## **Addendum #2**

**Bid Opportunity: 7251-RW-22**

### **Waterloo Oxford District Secondary School - Family Studies Renovation & HVAC Upgrades**

ASK-005

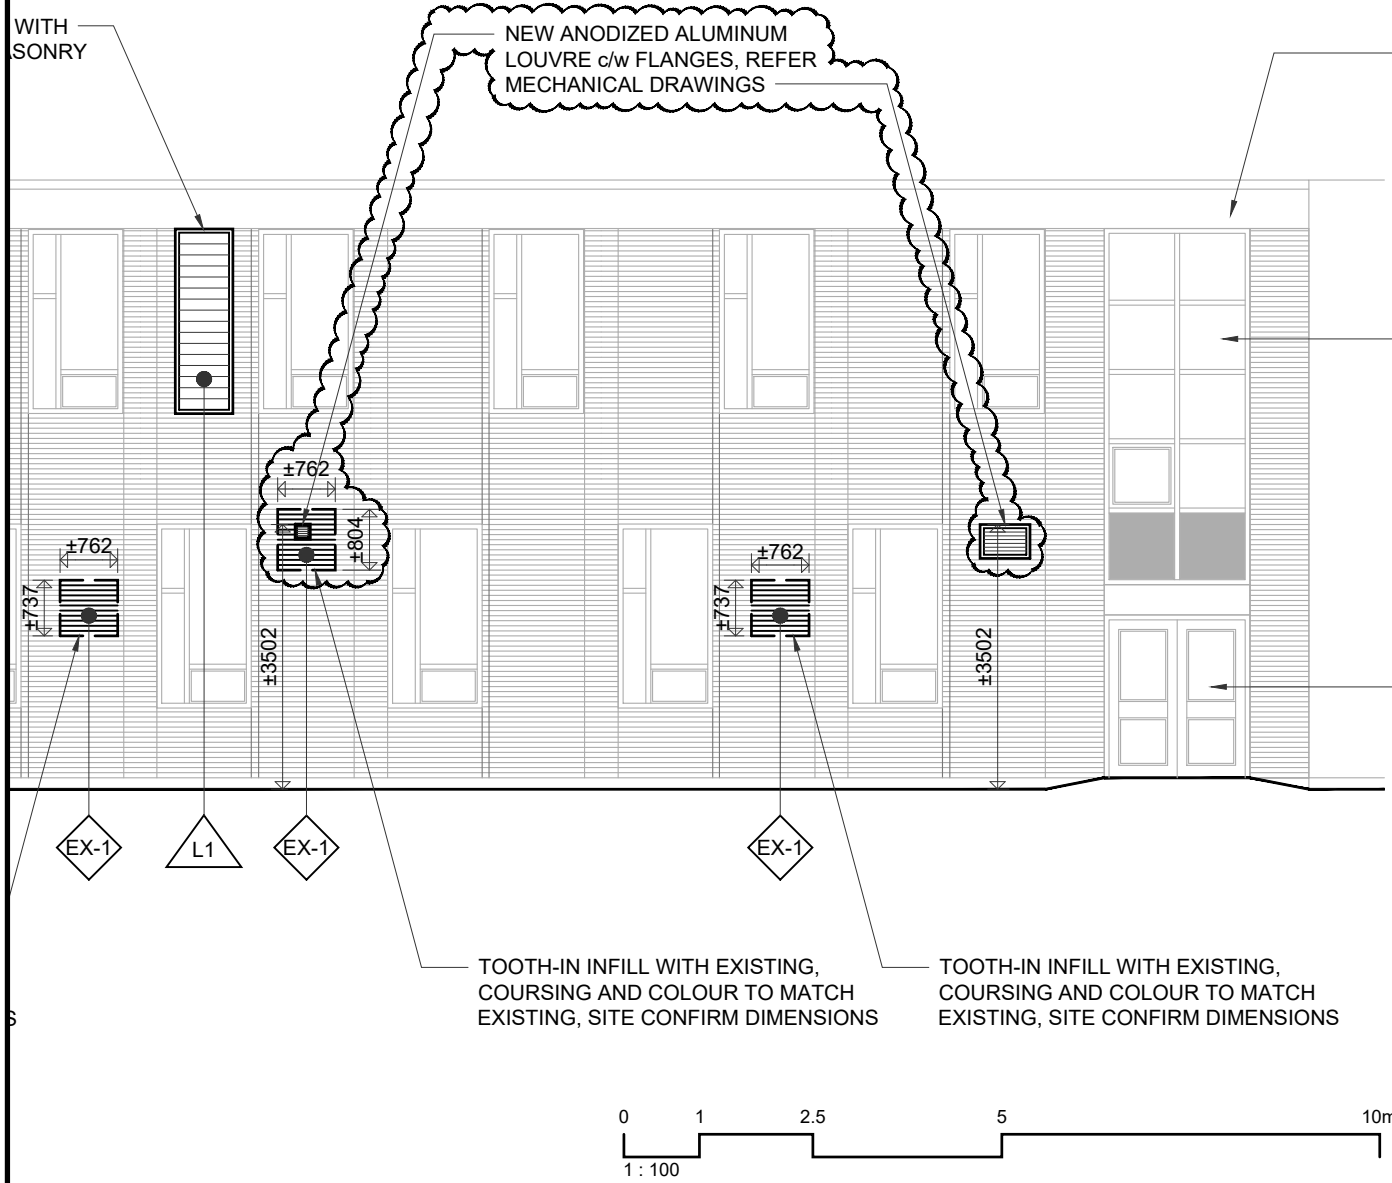
8. Drawing A5.0 Exterior Elevation, Frame Elevations, Door Elevation, Room Finish Schedule, Door Schedule
  1. **EAST EXTERIOR ELEVATION 1/A5.0 – PROVIDE LOUVRES AS SHOWN ON DRAWING ASK-005, ATTACHED.**

S1.01

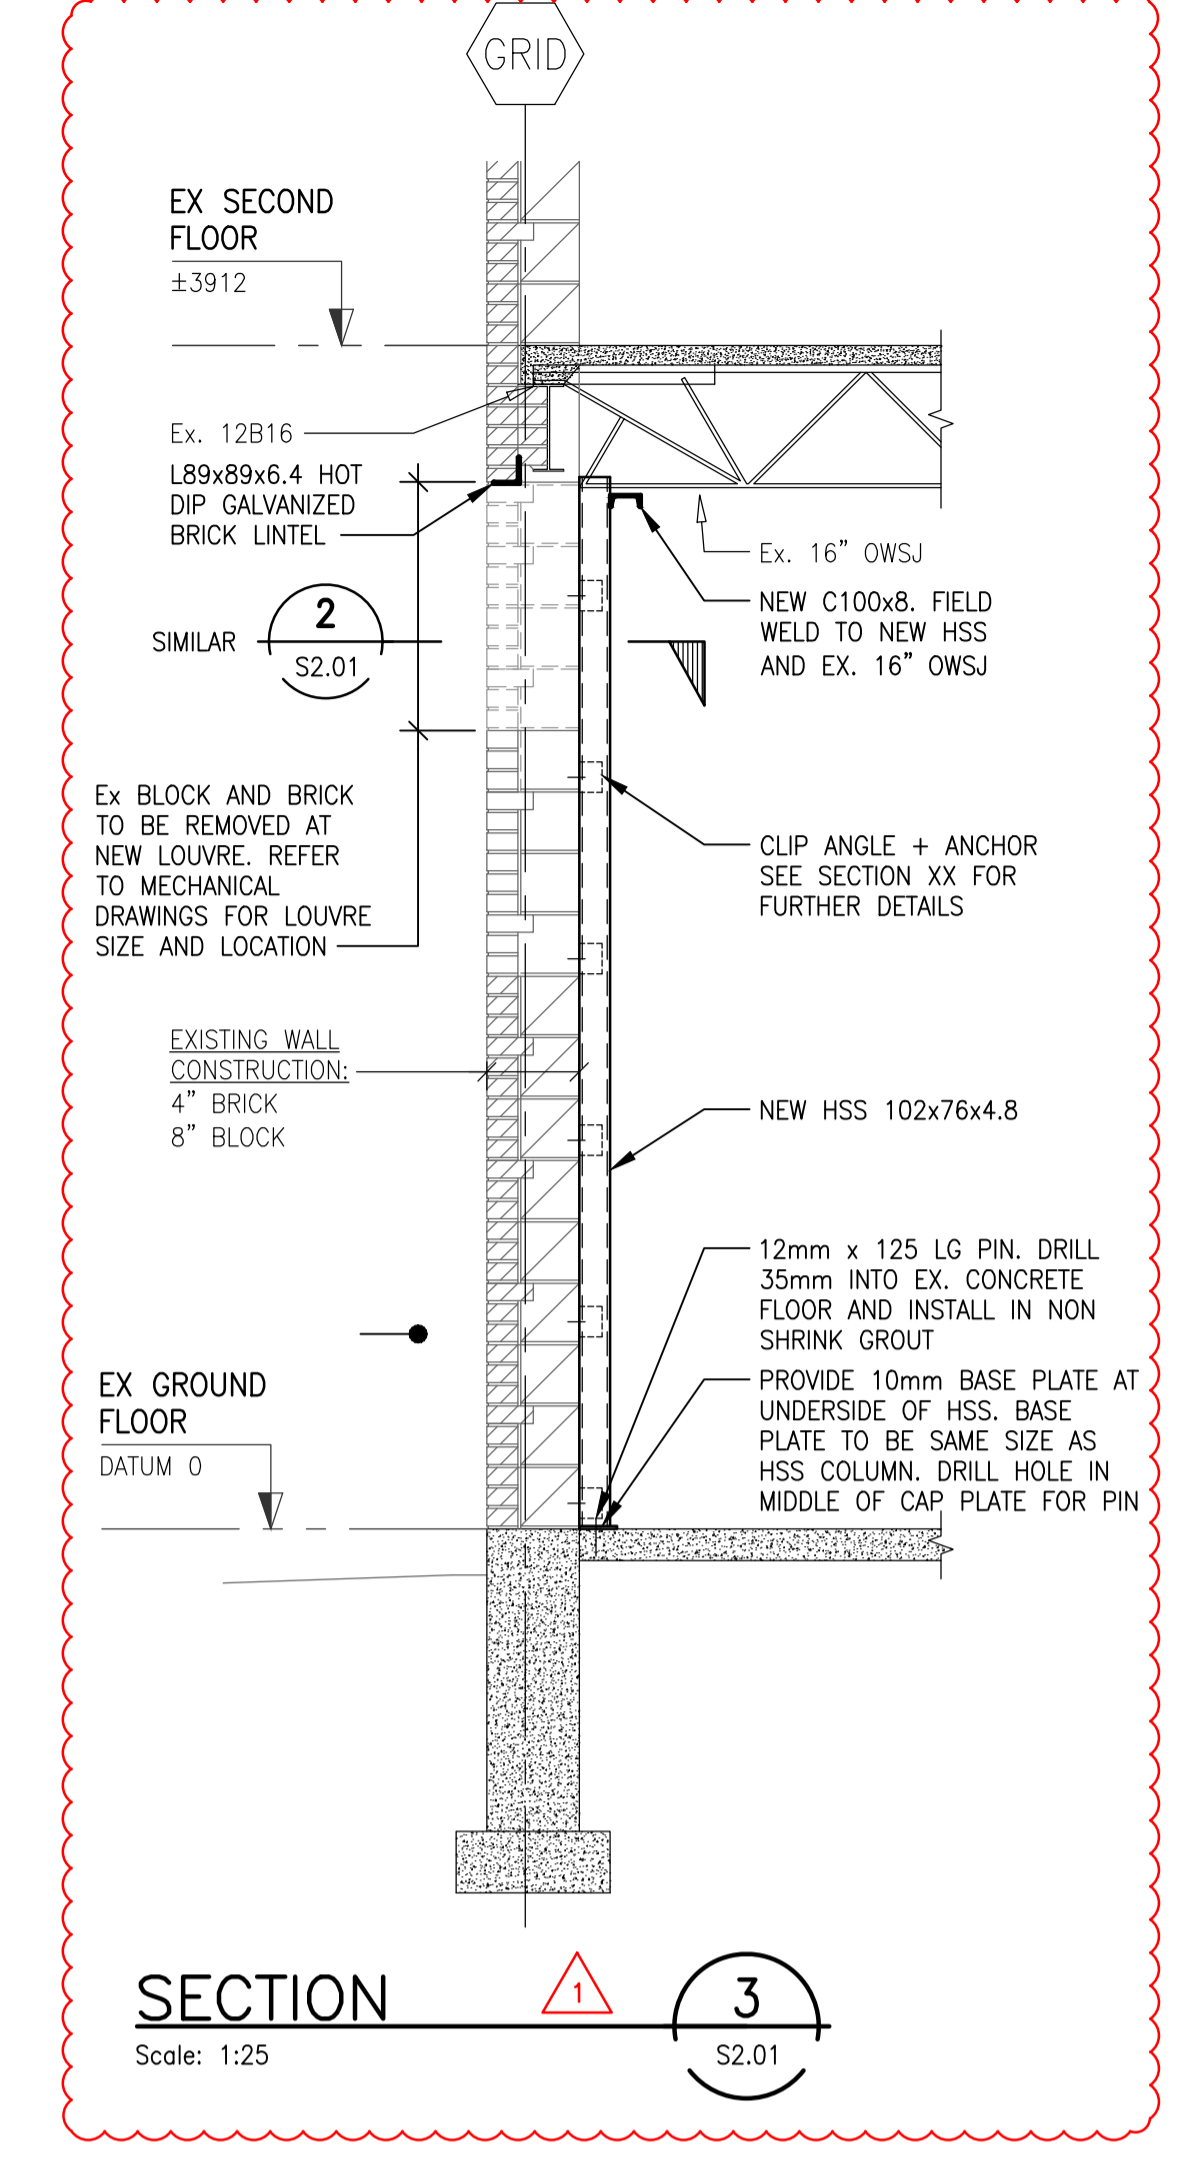
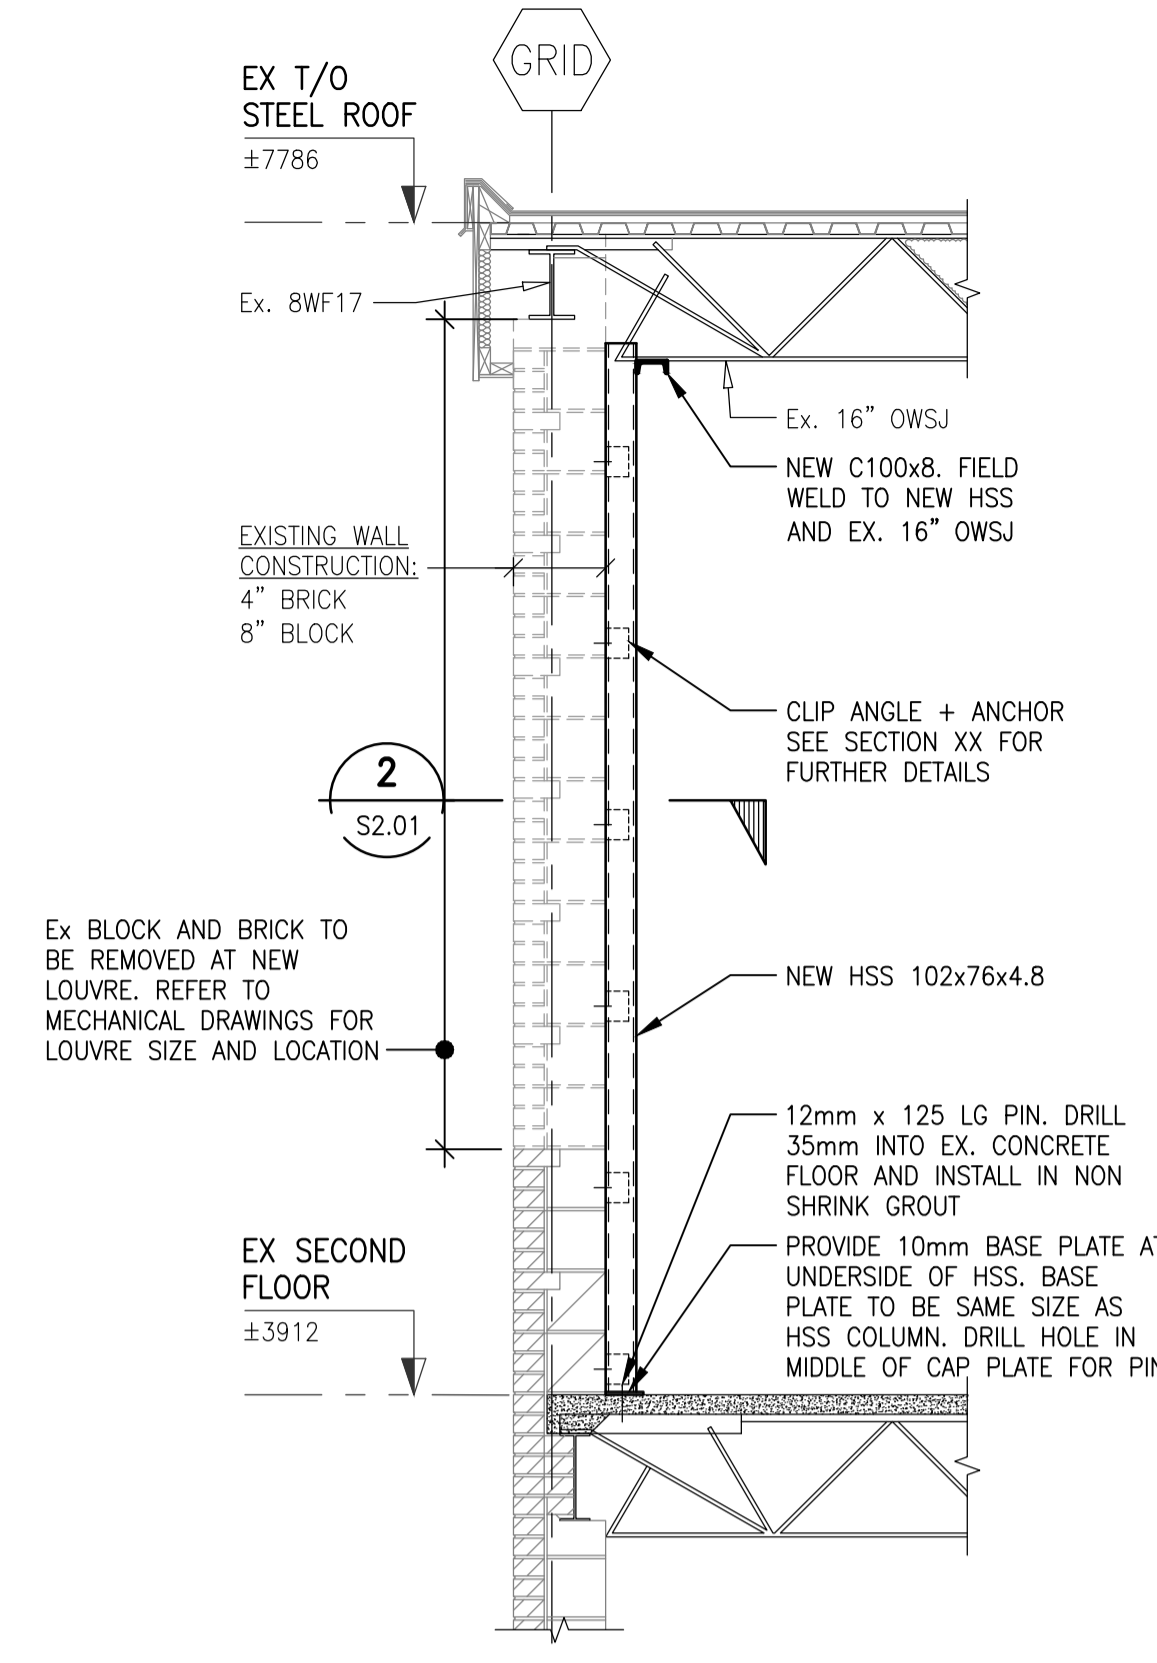
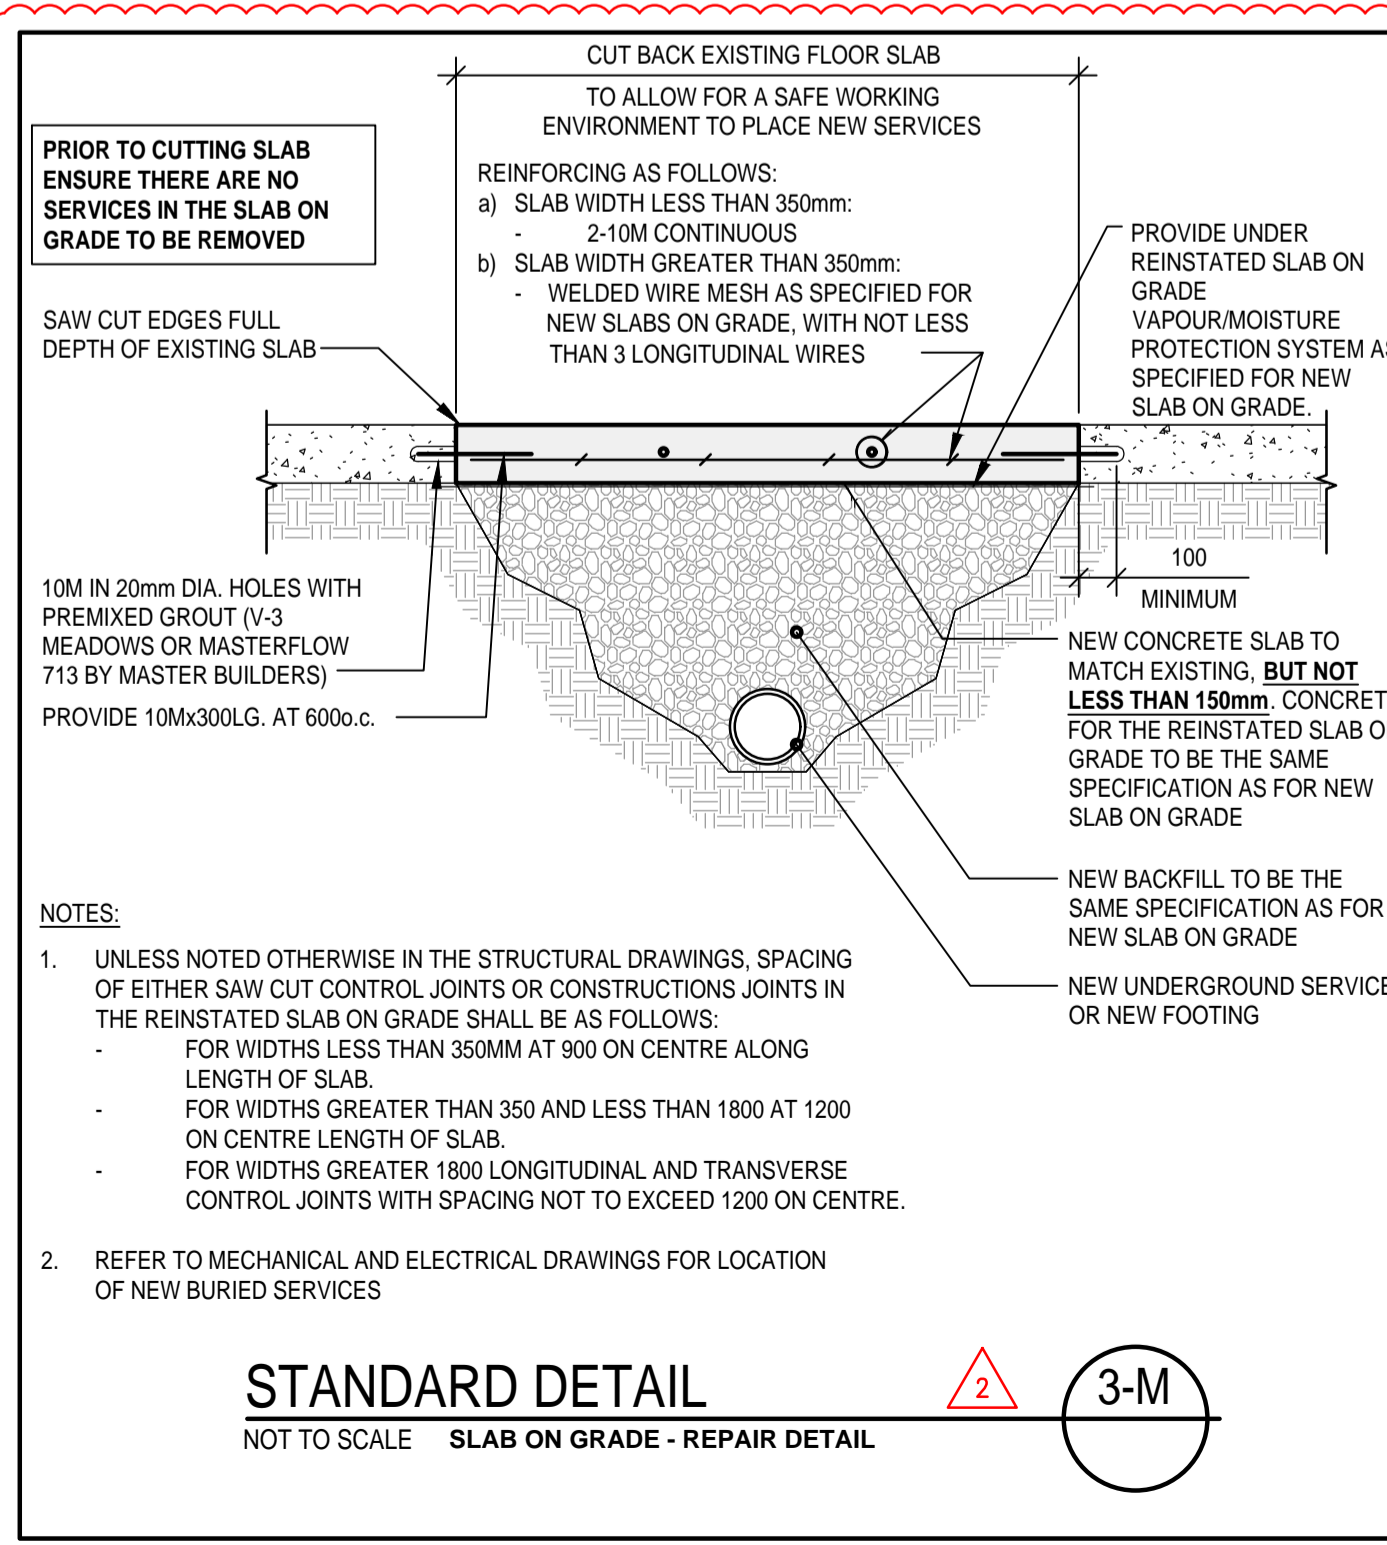
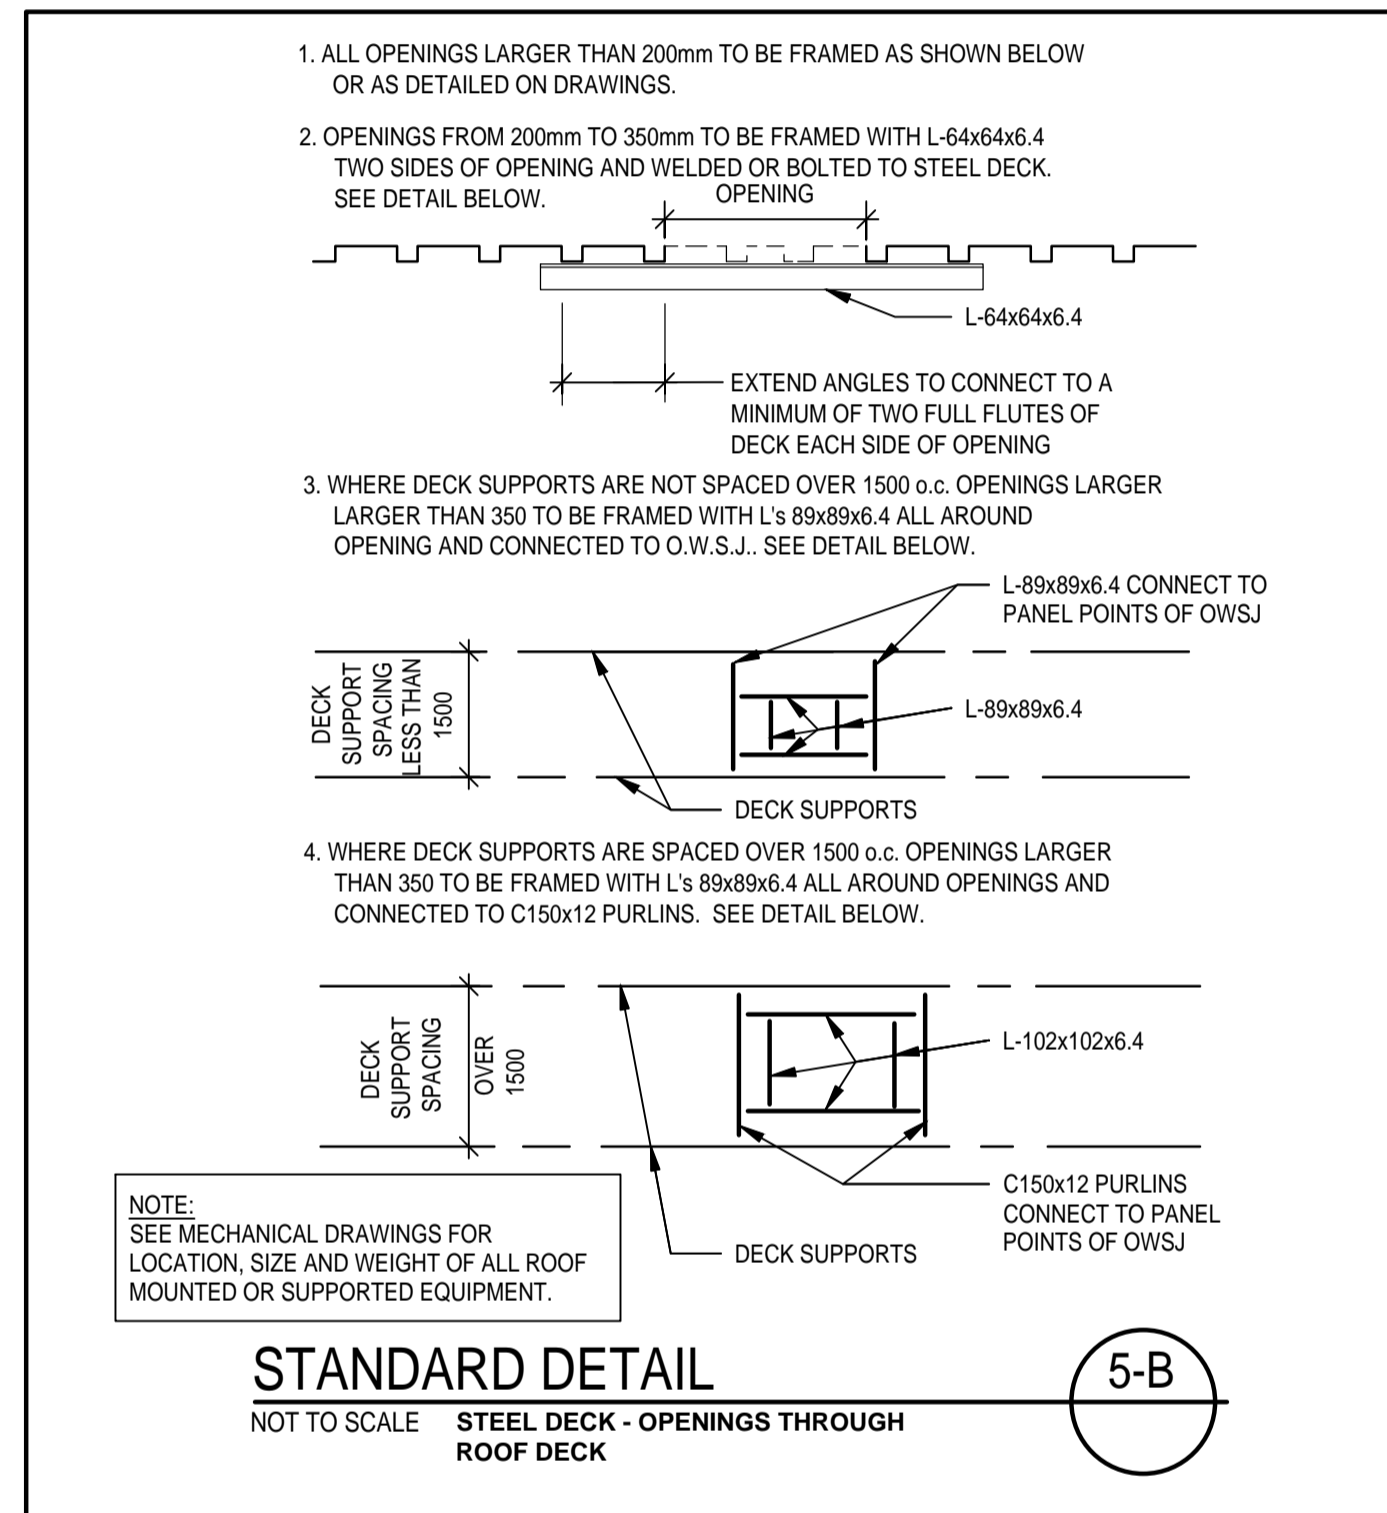
1. **REPLACE DRAWING S1.01 WITH DRAWING S1.01 ATTACHED.**
  1. **DETAIL 3-M ADDED TO DRAWING FOR SLAB ON GRADE REPAIR DETAILS.**
  2. **SECTION 3 ADDED TO DRAWING TO DETAIL STRUCTURE FOR LOUVRE OPENING IN IN NORTHEAST CORNER OF FAMILY STUDIES 103 ROOM.**
